State Significant Development Application (SSD 8816)

Precinct 4A, Royal North Shore Hospital
Development
St Leonards Health Organisations Relocation
(SHOR)

Submitted to Department of Planning &
Environment
On behalf of NSW Health Infrastructure

11 May 2018 | 16611

Figure 1 Section through Herbert Street Pedestrian Bridge

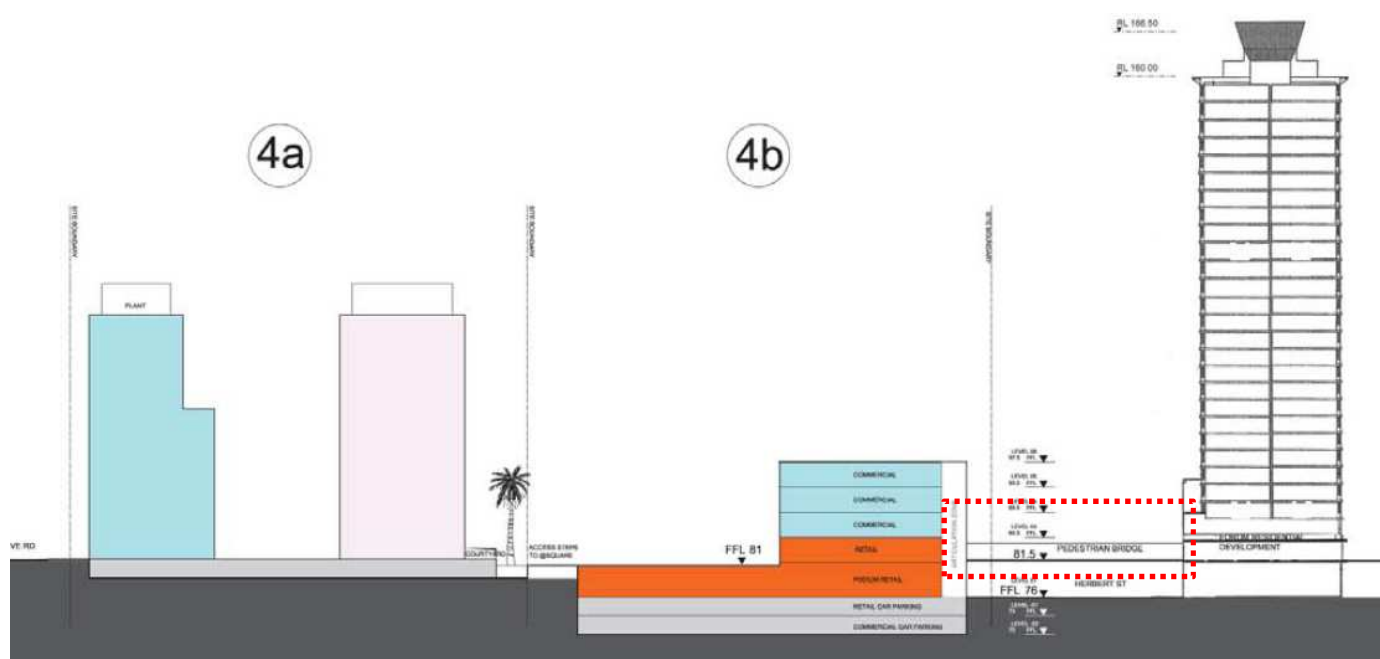
Realignment and refurbishment of the existing Herbert Street Pedestrian Bridge is requested to be carried out as part of the redevelopment of the site on the basis that the Statement of Commitments call for the works to be undertaken prior to the occupation of any building in Precinct 4.

The applicant acknowledges that realignment of the Herbert Street pedestrian bridge is identified as a Statement of Commitment (SoC) under the Concept Plan approval (MP 06_0051). The timing for this realignment is prior to occupation of any Precinct 4 building. Realignment plans are also to be submitted with any Precinct 4 project application. While there are no further Project Applications following the repeal of Part 3A, the work to realign the Herbert Street pedestrian bridge would be premature at this point in the development of Precinct 4.

As stated in the EIS, the pedestrian bridge realignment is directly impacted by the future development of Site 4B and should be undertaken as part of any future redevelopment of that site. The realigned pedestrian bridge would have an opportunity to connect directly with the building on Site 4B. This is consistent with the Concept Plan as illustrated by Figure 53 of the Concept Approval Plan which identified the pedestrian bridge links between the Forum and Site 4B building.

In order to partly satisfy the SoC as part of this application, the proposal provides a continuous pedestrian travel route from Site 4A and a suspended ramp that connects to the existing pedestrian bridge. This satisfies the intent of the SoC which is to provide a safe, alternate and continuous path of travel to St Leonards Station. The continuous path of travel and the suspension bridge will be delivered prior to the occupation of any Precinct 4 building. The proposed suspended ramp provides a temporary solution. It will allow a new realigned bridge to be delivered as part of any future Site 4B development.

Refurbishing the existing bridge as part of the Site 4A application is futile without understanding the future development plans for Site 4B. Any realignment of the pedestrian bridge at this stage of development of Site 4 would likely require the structure to be altered, redesigned or demolished to integrate with the Site 4B development in the future.

Realignment and refurbishment of Herbert Street pedestrian bridge can be better improved and achieve a desirable urban design outcome as part of the design of the built form of Site 4B given the detail of these works are unknown at this time.

Figure 2 Areas of Archaeological Potential

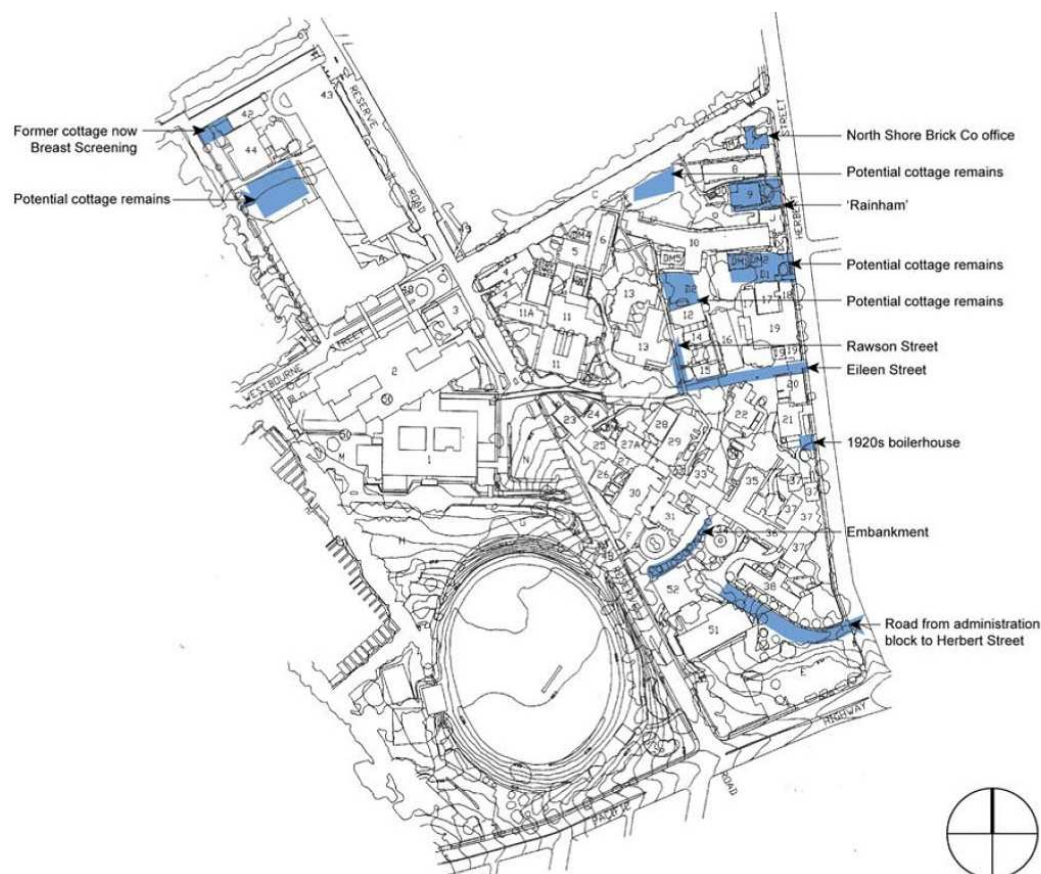
- *All excavation works in areas identified in Figure 4.2 in the GML 2006 Archaeological Assessment as having potential to contain historical archaeology of low to medium significance must be monitored by a suitably qualified and experienced historical archaeologist.*
- *The historical archaeologist must take adequate steps to record in detail any archaeological relics, structures and features discovered on the site during the excavation works in accordance with current best practice*

The recommended conditions of consent are acknowledged by the applicant. Further investigation has confirmed that a part of Precinct 4, as shown in blue below, is identified as being an area of low to medium archaeological significance. Accordingly, necessary steps will be taken to ensure that excavation of these areas are monitored.
